Petition: **#317-23**
Public Hearing: ----
10/17/23

PUBLIC HEARING MEMORANDUM

SUBJECT: **Petition #317-23** for SPECIAL PERMIT/SITE PLAN APPROVAL to demolish the existing dwelling and construct six single-family attached dwellings in three separate structures at **280 Nevada Street**, Ward 1, Newtonville, on land known as Section 14 Block 08 Lot 12, containing approximately 29,550 sq. ft. of land in a district zoned MULTI RESIDENCE 1. Ref: Sec. 7.3.3, 3.4.1, 3.2.4, 5.1.8.A.1, 5.1.13, 5.1.8.C, 5.1.9, 5.1.10.A, 5.4.2.B, 6.2.3.B.2 of Chapter 30 of the City of Newton Rev Zoning Ord, 2017

280 Nevada Street

Proposed Right and Front Elevations

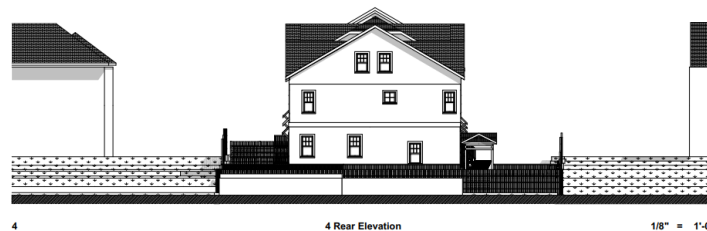
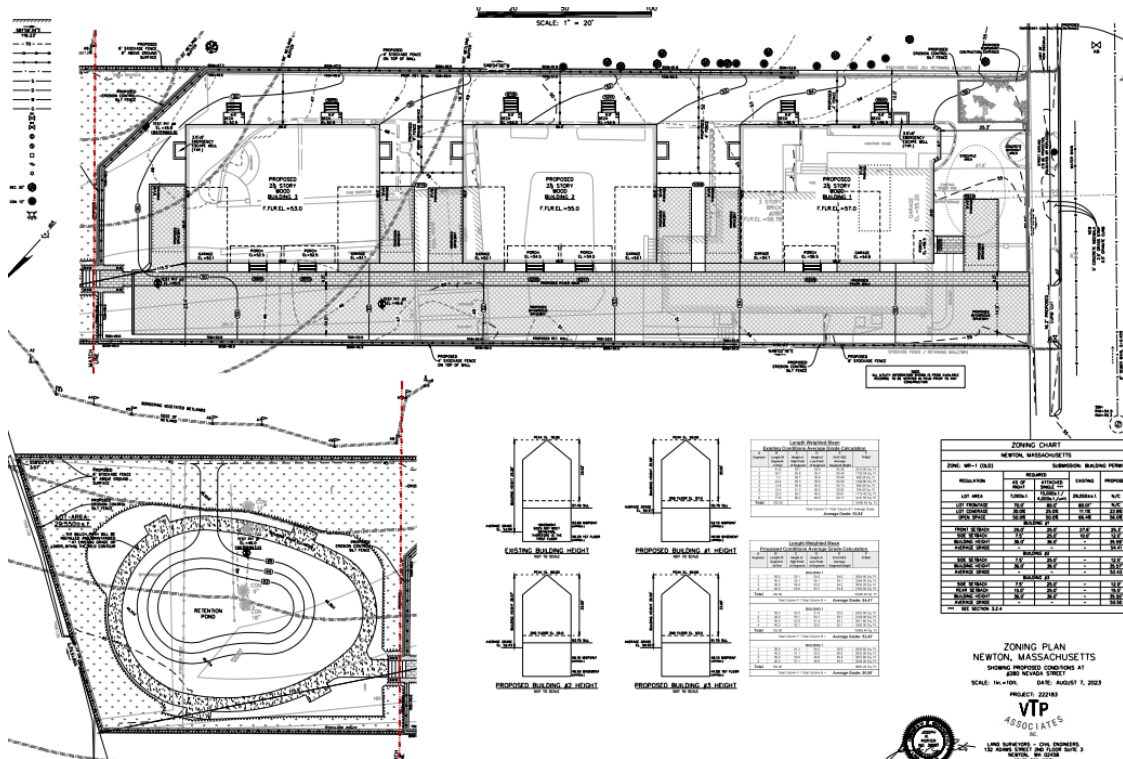
Attached single family dwellings are required to have all side, front and rear setbacks measure at least 25 feet. At 25.3 and 115.5 feet, respectively, the proposed front and rear setbacks comply. At 23.4 feet the left side is slightly noncompliant while at 16.2 feet the right side setback is almost nine feet less than the requirement.

Looking towards Nevada St. this driveway will be eliminated.

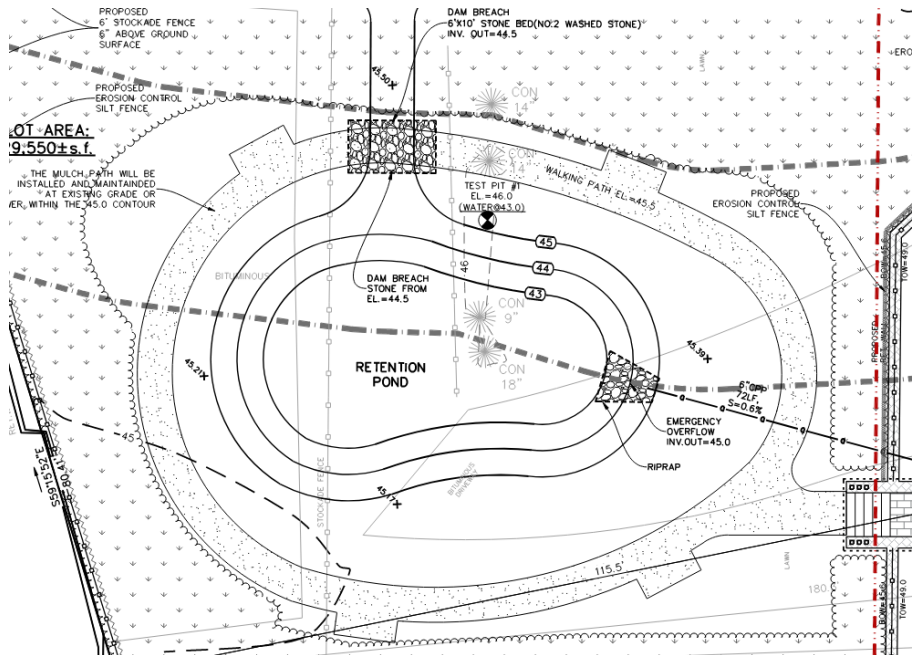
Currently access to the site is from two driveway aprons providing a “horseshoe” driveway in the front of the house and a long driveway along the southeast property line.
